# CITY OF ALBUQUERQUE

RE: **Lot 1 Block 5, S.A.D. 227**  
**Unser Cliffs Subdivision**  
**6524 Onyx Ct. NW**  
**Grading and Drainage Plan**  
**Engineers Stamp Date 10-26-18 (E10D053)**

RE: **Lot 1 Block 5, S.A.D. 227**  
**Unser Cliffs Subdivision**  
**6524 Onyx Ct. NW**  
**Grading and Drainage Plan**  
**Engineers Stamp Date 10-24-18 (E10D053)**

6524 ONYX CT. NW, ALBUQUERQUE, NM 87120	CITY OF ALBUQUERQUE, BERNALILLO COUNTY	NEW MEXICO
LOT 1, BLOCK 5 UNSER CLIFFS SUBDIVISION		
LANG LOT 1 - GRADING & DRAINAGE PLAN		
McDowell Engineering, Inc.		
7820 BEVERLY HILLS AVE. NE ALBUQUERQUE, NM 87122		
TELE: 505-828-2430 FAX: 505-821-4857		
Designed JSM	Drawn STAFF	Checked JSM
File LAN0218L	Date OCTOBER,2018	Sheet 1 of 1

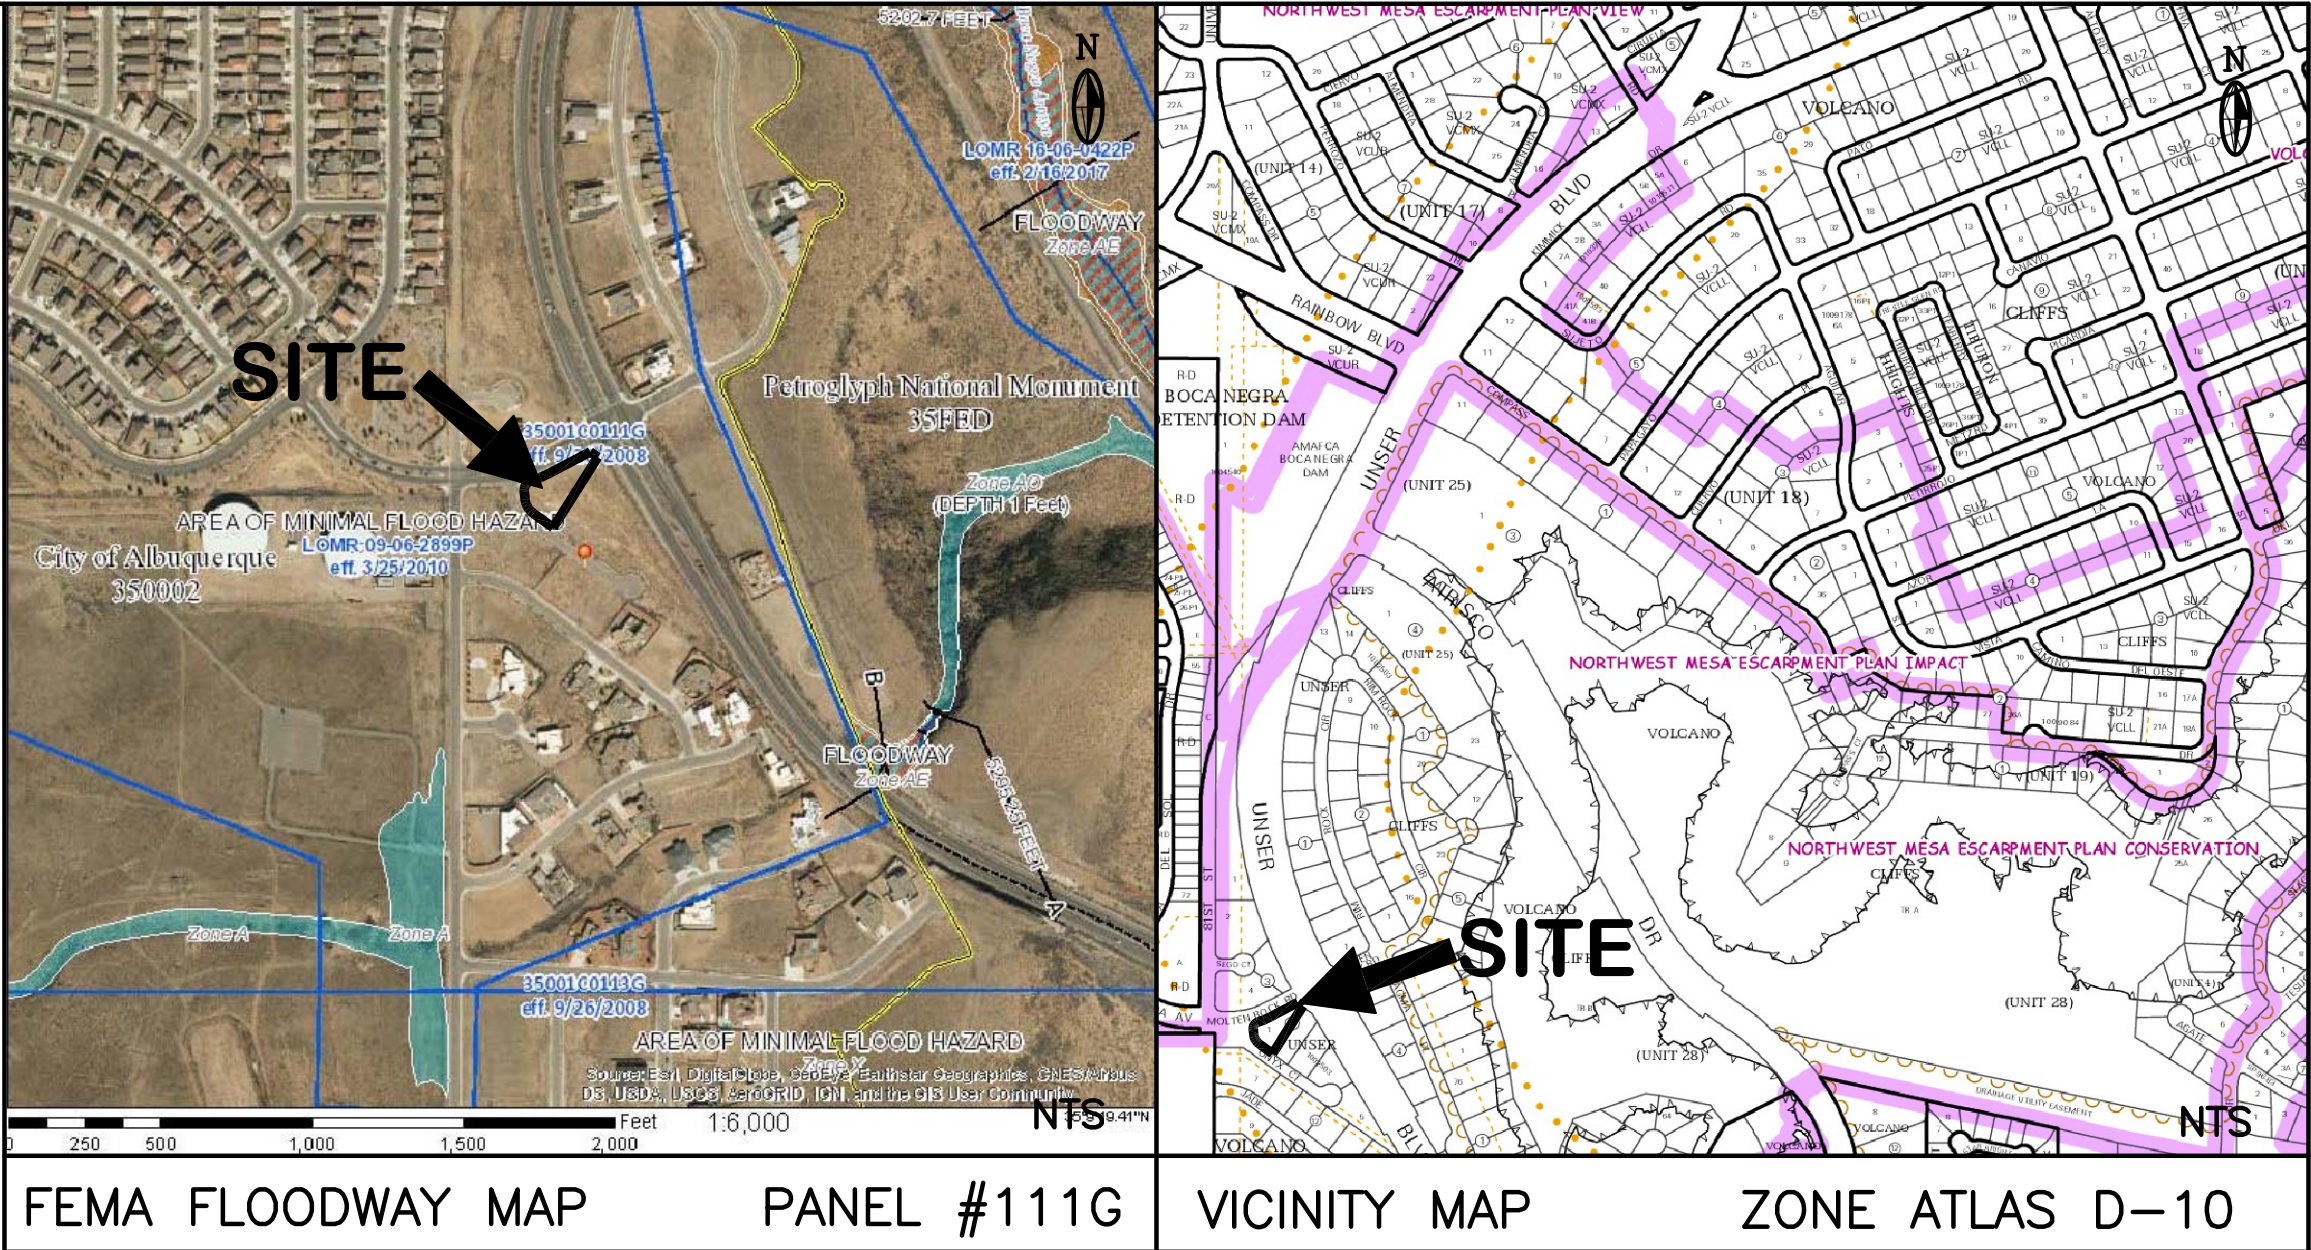
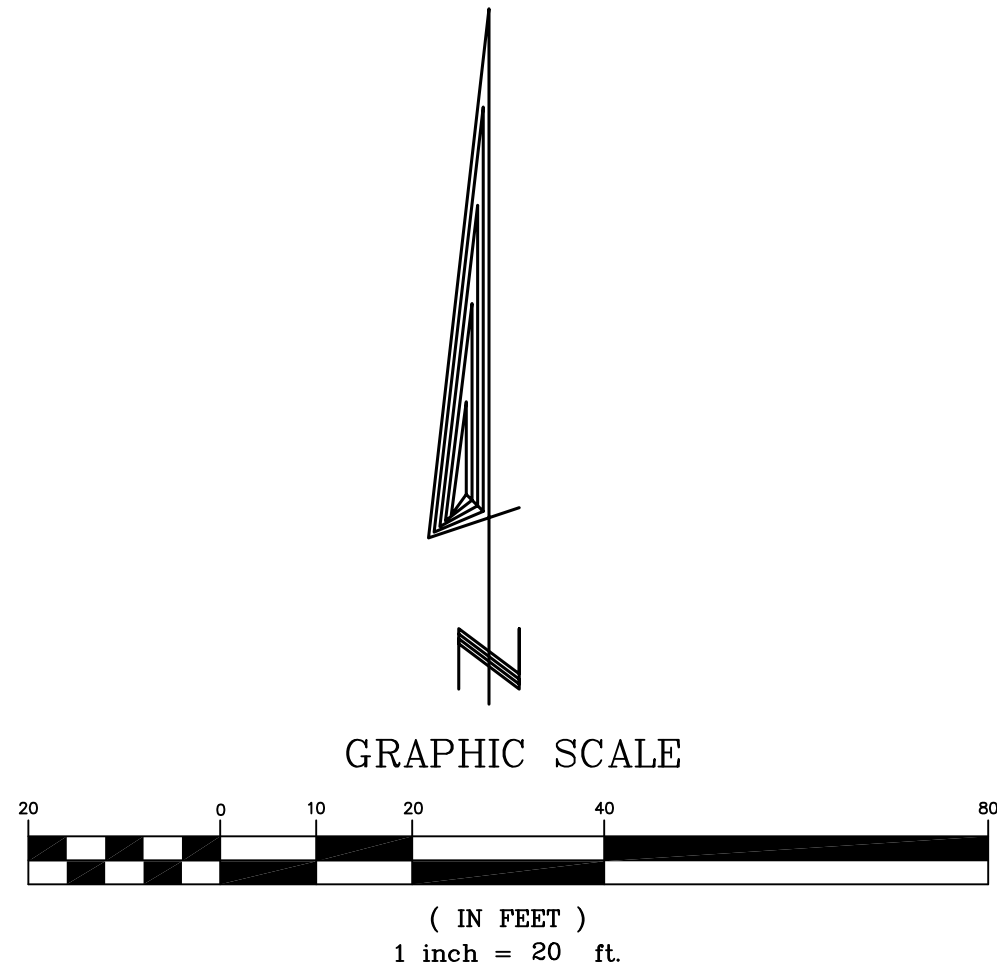
Based upon the information provided in your submittal received 10/23/18, this plan cannot be approved for Grading Permit until the following comments are addressed.

- Direct all flows to exit onto Onyx Ct. through a sediment capture pond. **OK-modified.**
- Cross lot drainage is not required; remove the turn blocks on the eastern garden wall. **OK-modified.**
- Remove the 7' PUE on the Molten Rock Rd. side. **OK-modified.**
